FIRST HILL BPS SYSTEM TUNING RFQ NUMBER: 25-31 ADDENDUM NO. 2

This addendum is for the First Hill BPS System Tuning request for qualifications, RFQ No. 25-31, issued June 5, 2025. This document provides agency responses to questions received following the release of Addendum No. 1 and up to the official question submittal deadline.

- 1. ADDENDUM No.02, dated June 25, 2025, containing answers to questions received. Total of 1 page.
- 2. Station Mechanical Plan_Rev.D*. Total of 2 pages.
- 3. Email approving and describing changes of new Rev.E*. Total of 4 pages.
- 4. Station Mechanical Plan_Rev.E*. Total of 1 page.
- 5. Station Exterior Piping as-built sketch. Total of 1 page.

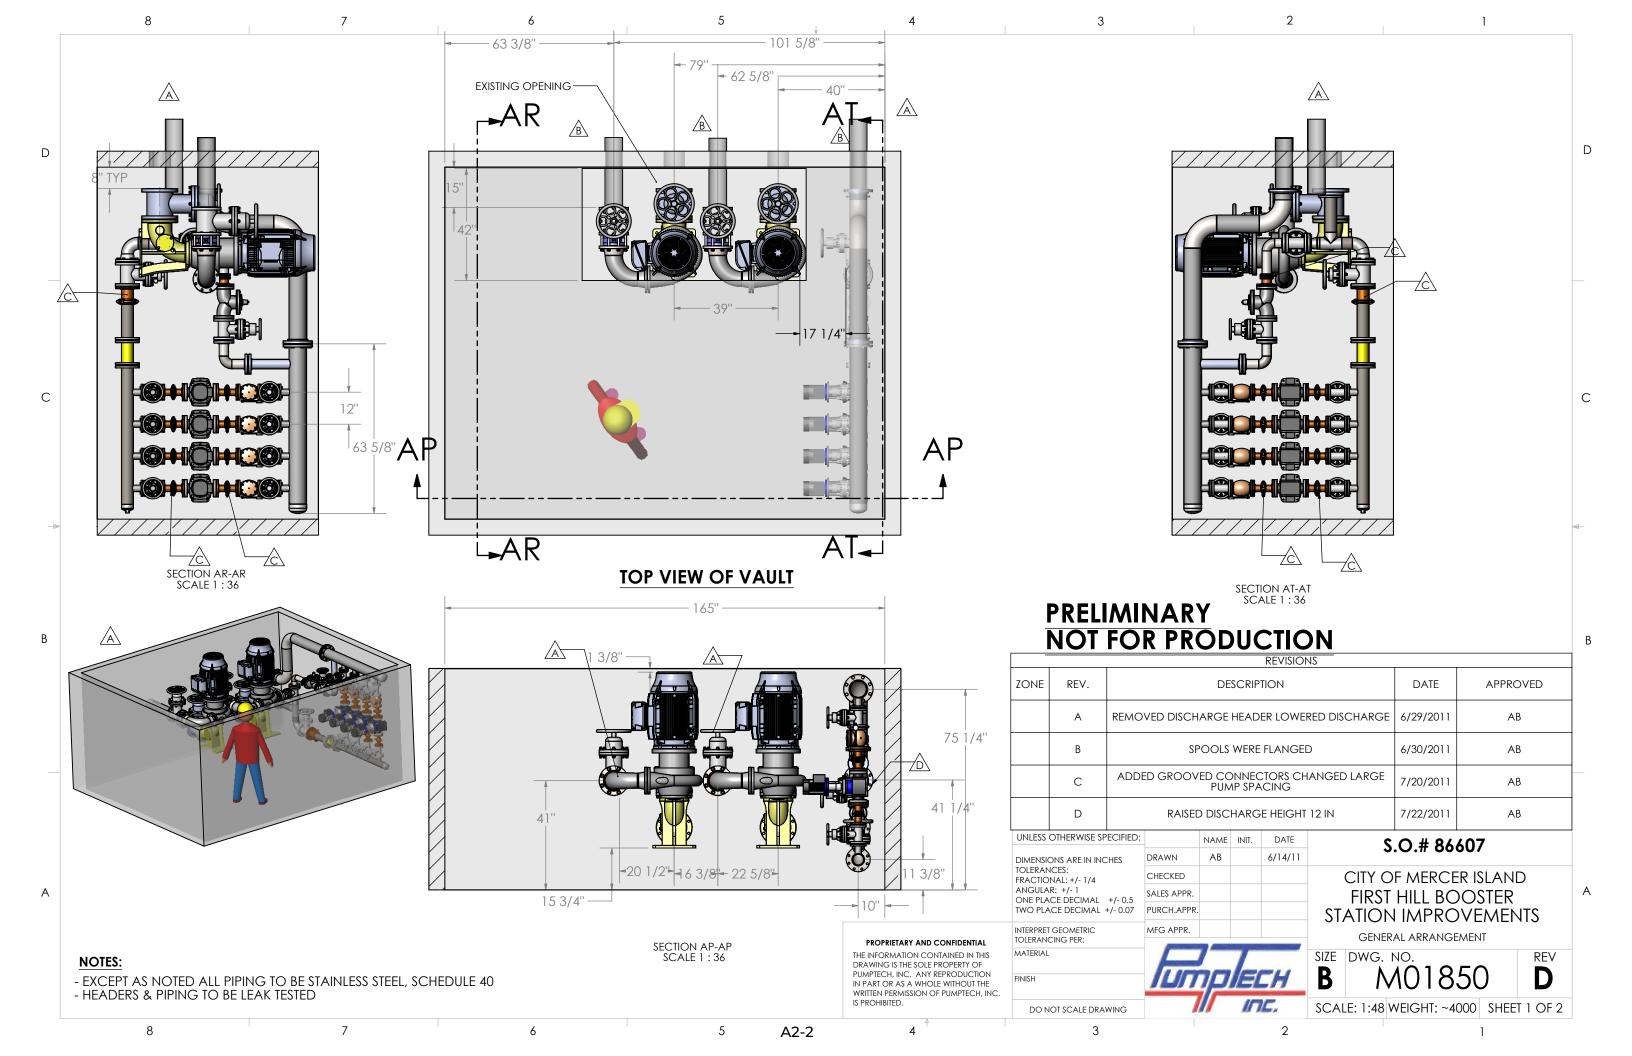
of the Permanent Pump System, Revision D! In there, Jack indicated that the clearance above the large pumps was only 1-3/8 inches. Since the hole was excavated and everything is now fully exposed, Mark said he would try lowering the suction line as much as possible (as low as he can go and still leave a bit of room above the storm pipe). After Jack coming to look at it again, he made one more revision -- Revision E.

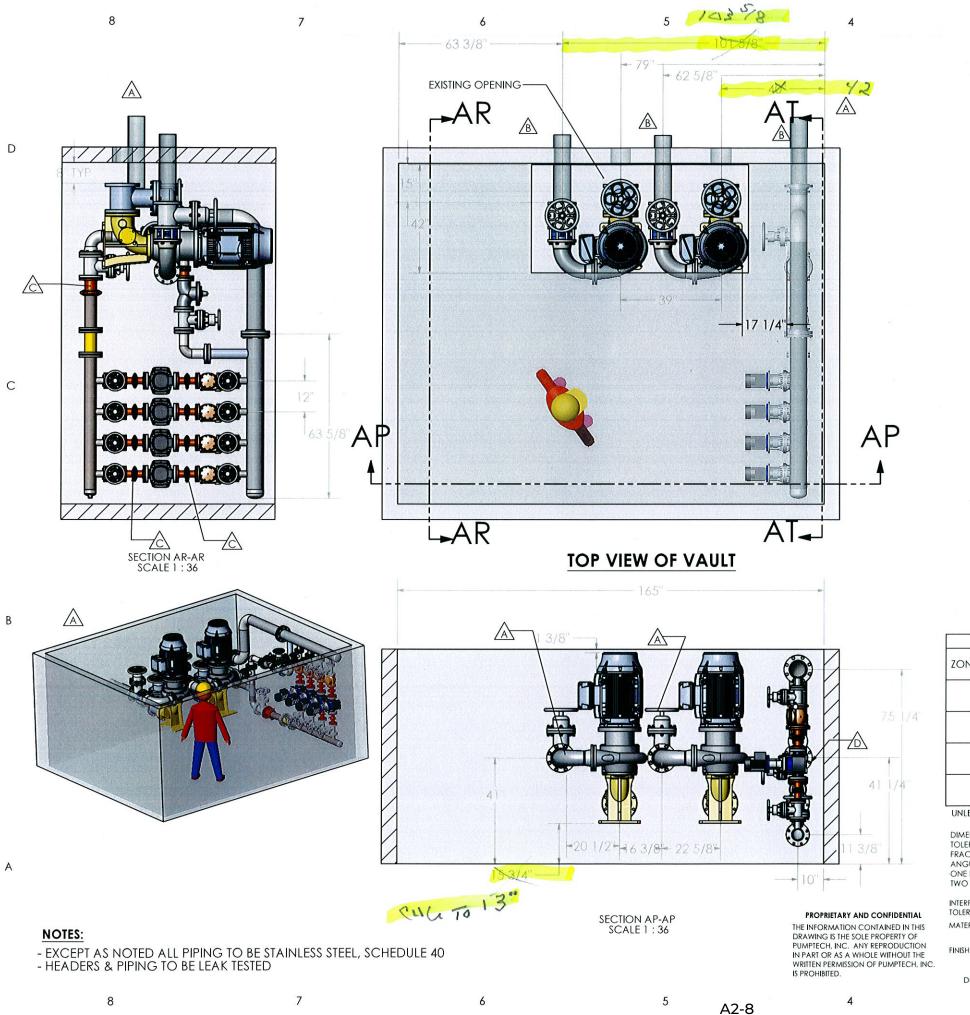
Attached in the PDF is the 'final' revision of the Permanent Pumping System submitted by PumpTech. This is Revision E. It's Revision D with changes marked by hand written notes. The only changes in Revision E, different from Revision D, are 1) lower the base on the large pumps by 2-3/4 inches, and 2) move both of them 2 inches toward west.

David - These adjustments reflect C/L changes for the pipe penetrations in the vault and identifies the vertical plane for suction and discharge piping. We need confirmation from all first, and then I'll adjust the drawing to reflect those changes

REV D with 7/27/11 adjustments to dimensions...

Since everyone had already "agreed" to REV D...which addressed the City's/HDR comment of equipment/valve removal from REV B...REV E should not be an issue.

The attached pdf is "A - Furnished as Submitted".
